Enclosed is a Draft Biannual Report for the project "Evaluation and Compilation of DOE Waste Package Test Data" (FIN-A-4171-7). Comments by your staff and contractors are requested as soon as is practical, so that complete responses by NBS staff can be prepared and incorporated in a timely manner.

EVALUATION AND COMPILATION OF DOE
WASTE PACKAGE TEST DATA

DRAFT BIENNIAL REPORT
Covering the Period February 1987 to July 1987

Figure 1. Normalized Si Release (Chick, et al. 1984) predicted by cubic model from 101 data points (TOP) and quadratic model from 76 data points (BOTTOM).

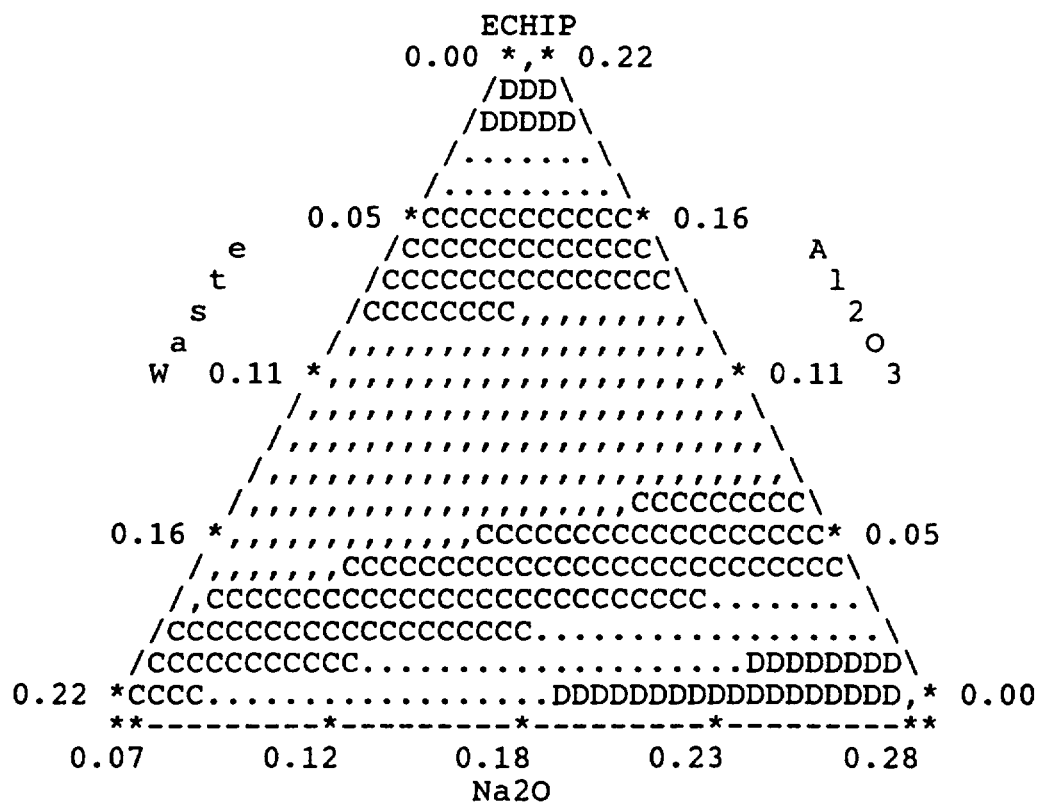
Our comparison of the two models is based on the contour plots shown in Figures 1-4. Before discussing the comparison, we consider the interpretation of these plots. Consider the top plot in Figure 1. This plot shows the logarithm of the normalized Si release for the 28-day MCC-1 test as a function of the seven components that make up the glass [Chick, 1984]. Of the seven components, three are allowed to vary in each of these contour plots and the other four are held constant at the proportions for the glass recommended as optimum in the study, SiO_2 0.454, B_2O_3 0.024, Na_2O 0.155, CaO 0.102, Al_2O_3 0.009, Fe_2O_3 0.135, and Waste 0.121. The level of the response is shown by the letters, and a scale for the letters is shown on the right of the plot. Note that the B's in the middle of the plot indicate a minimum in the Si release. In the plot on top of Figure 1, the response is shown as a function of Al_2O_3 , Na_2O , and Waste. These three components must add to 0.285 since the other four components are fixed. The component Al_2O_3 is

The two contour plots in Figure 1 contrast the original cubic model shown on the top with the alternative quadratic model shown on the bottom. The two plots are generally similar. However, the quadratic model does not show a distinct minimum in the middle as the cubic model does. Rather, the quadratic model suggests that better leach performance can be obtained by substituting Al_2O_3 for Na_2O while holding the waste proportion constant.

Figure 3. Normalized Waste Release (Chick, et al. 1984) predicted by quadratic model from 76 data points.

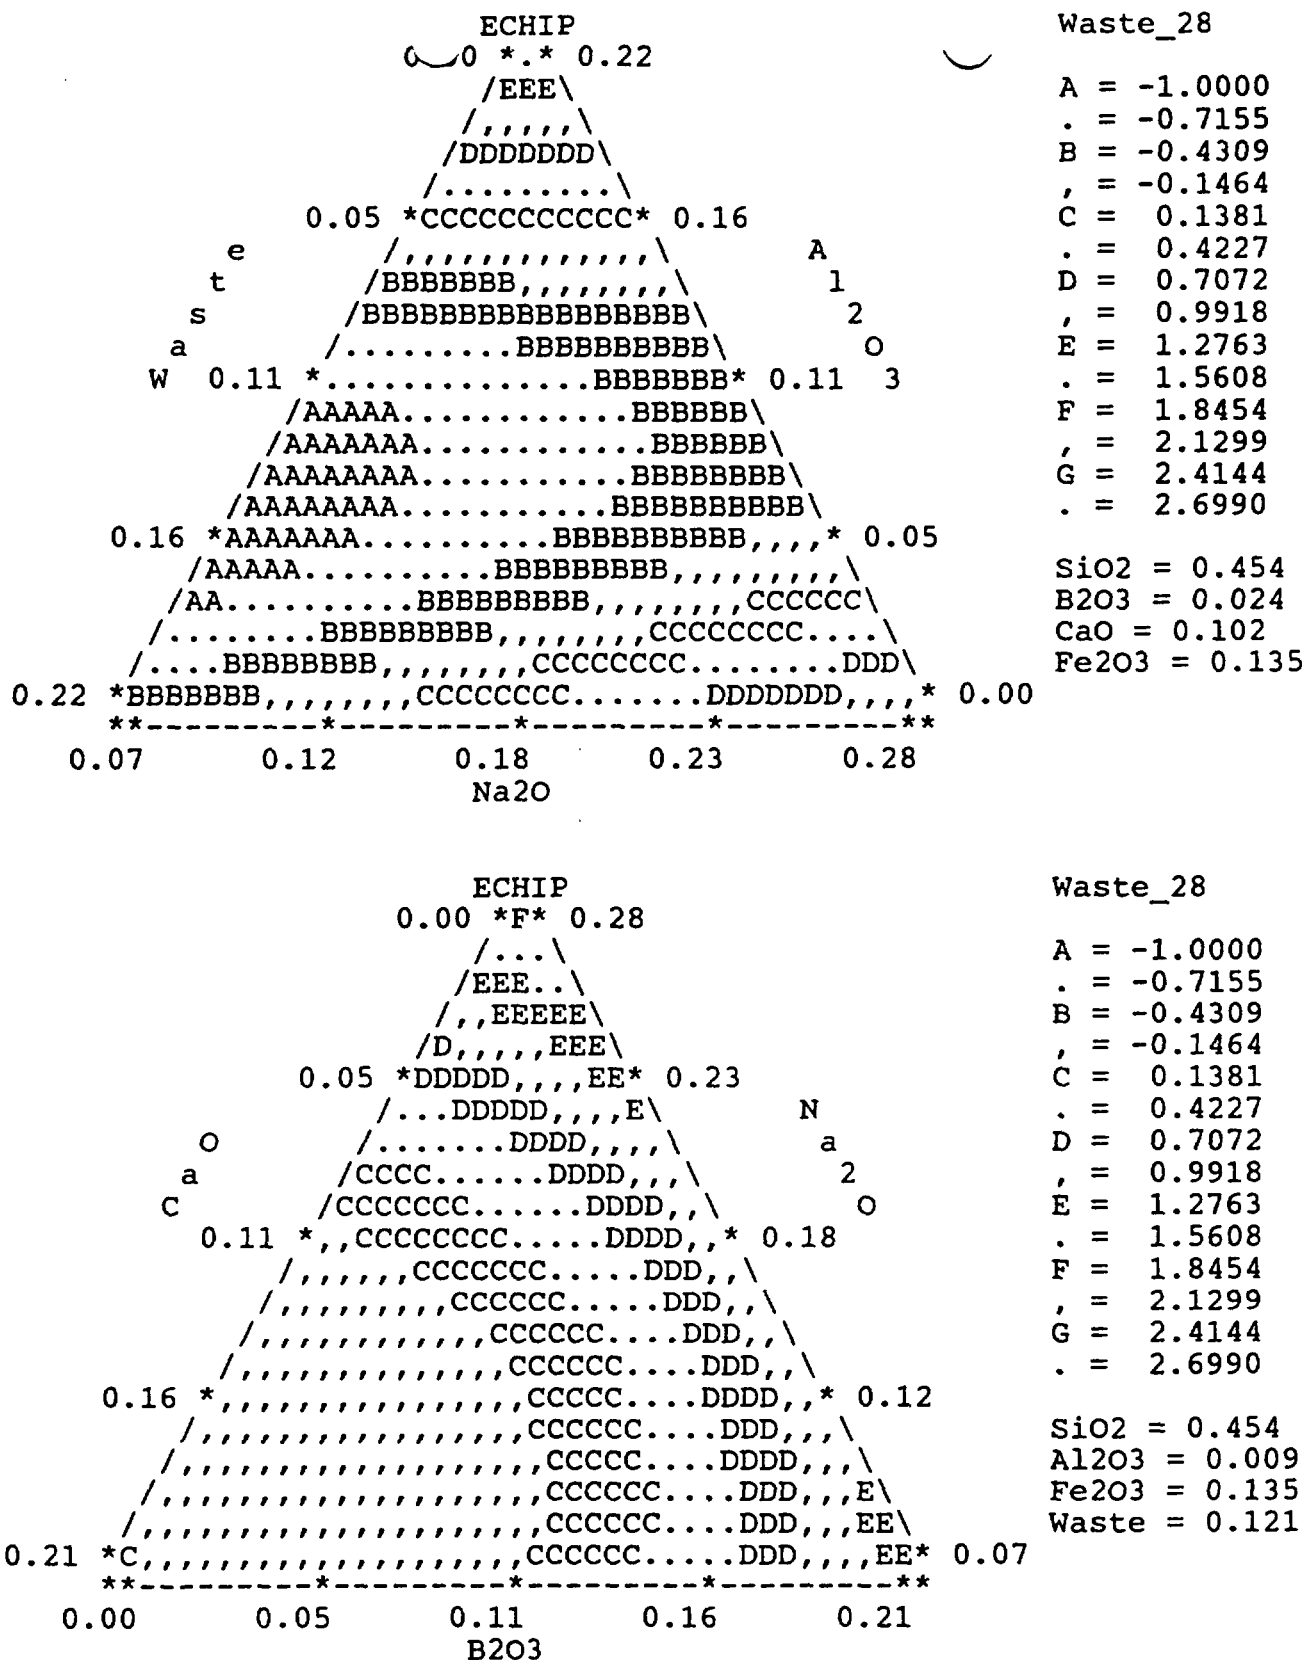
Figure 3 shows the quadratic model obtained for another leach component, the logarithm of the normalized Waste from the 28-day MCC-1 test. The top plot shows the same components as Figure 1, and the bottom plot shows the same components as Figure 2. The top plot shows distinctly that better leach performance can be obtained by substituting Al_2O_3 for Na_2O while holding the Waste constant. The bottom plot supports the assertion in the original study that better performance is obtained with higher CaO and correspondingly lower B_2O_3 .

Figure 4. Composite Leach Measure (Chick, et al. 1984) predicted by quadratic model from 76 data points.

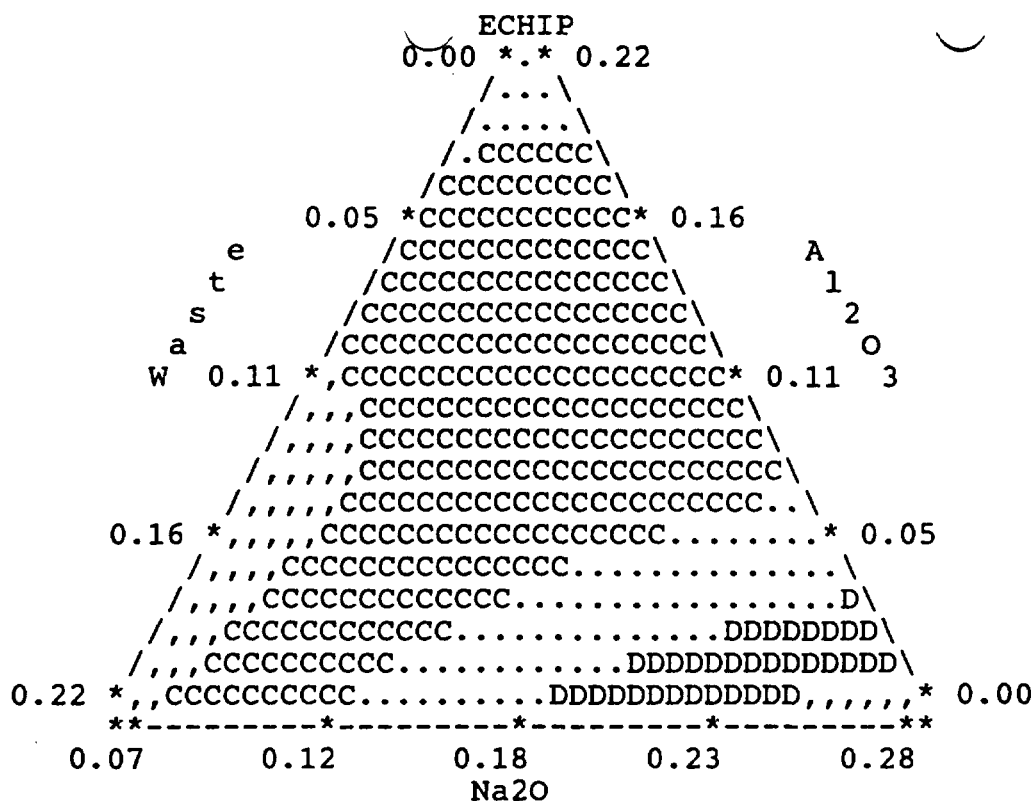
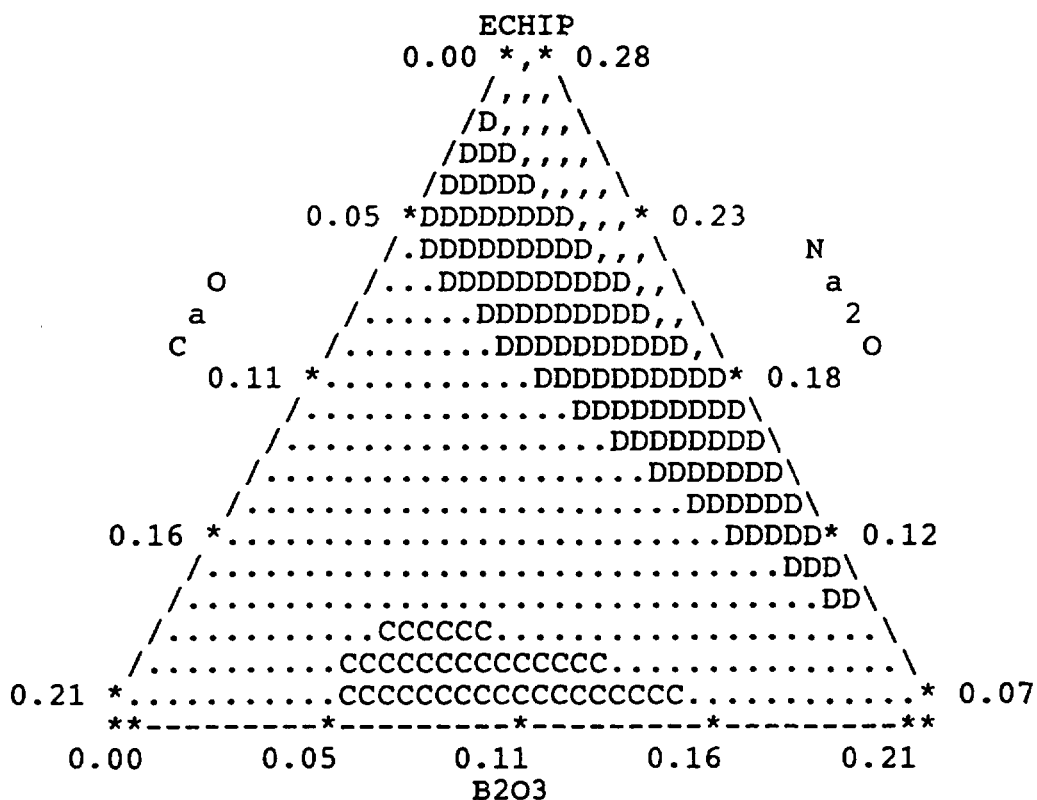
Figure 4 shows the quadratic model obtained from the composite leach measure used in the original study to judge leach performance. Again the top plot corresponds to Figure 1, and the bottom to Figure 2. The top plot shows better leach performance is obtained with more Al_2O_3 and less Na_2O . The bottom plot suggests that for low levels of Na_2O , the substitution of CaO for B_2O_3 can be carried too far.
